Access Compliance Report

Public Rights-of-Way

(Curb Ramps)

Intersection ID: 11625	Main Street: E_11TH_ST	Cross Street: N_COLLEGE_ST	Location: S
ADA ID: 167BEFF02C4D	Ramp Type: PerpDiag	Initial Pass/Fail: Fail	Overall Compliance: No
			Severity Score: 21.25

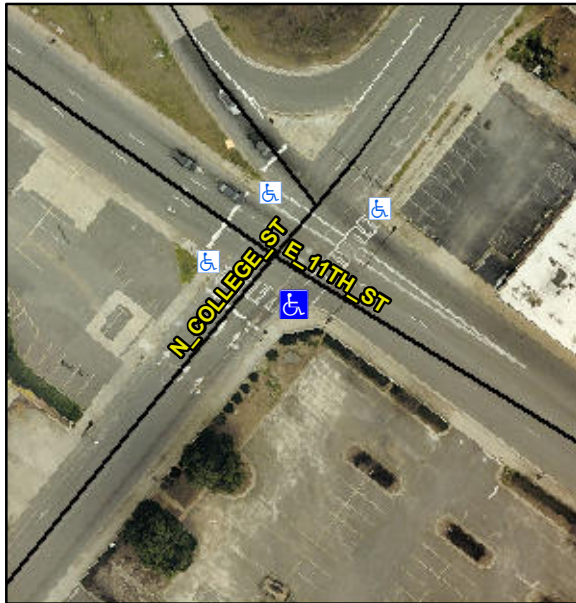
Not Found, R304.5.1, R304.2.2

Compliance	Description	Data	Compliance	Description	Data
N/A	Ramp Length (in)	57.0	No	Ramp Slope (%)	9.7
No	Ramp Width (in)	44.0	Yes	Ramp XSlope (%)	1.3
N/A	Flare Type LT	N/A	N/A	Flare Type RT	N/A
N/A	Flare Slope LT (%)	N/A	N/A	Flare Slope RT (%)	N/A
N/A	Flare Traversable LT?	N/A	N/A	Flare Traversable RT?	N/A
N/A	Landing Length (in)	N/A	N/A	DWS Provided?	N/A
N/A	Landing Width (in)	N/A	N/A	DWS Contrast?	N/A
N/A	Landing Slope (%)	N/A	N/A	DWS Length (in)	N/A
N/A	Landing X Slope (%)	N/A	N/A	DWS Full Width?	N/A
N/A	Landing Curb? (Y/N)	N/A	N/A	DWS Offset (in)	N/A
N/A	Shared Landing?	N/A			
N/A	Gutter Ponding?	N/A	N/A	Gutter Slope (%)	N/A
N/A	Gutter Lip Ht (in)	N/A	N/A	Gutter X Slope (%)	N/A
N/A	Painted X Walk1?	Yes	N/A	Painted X Walk2?	Yes
	X Walk 1 Direction	To NE		X Walk 2 Direction	To NW
N/A	X Walk 1 Width (in)	111.0	N/A	X Walk 2 Width (in)	118.0
	X Walk 1 Slope (%)	1.6		X Walk 2 Slope (%)	7.8
	X Walk 1 X Slope (%)	1.0		X Walk 2 X Slope (%)	2.1

Remove & Replace Curb Ramp With Two New Directional Ramps or Equivalent.
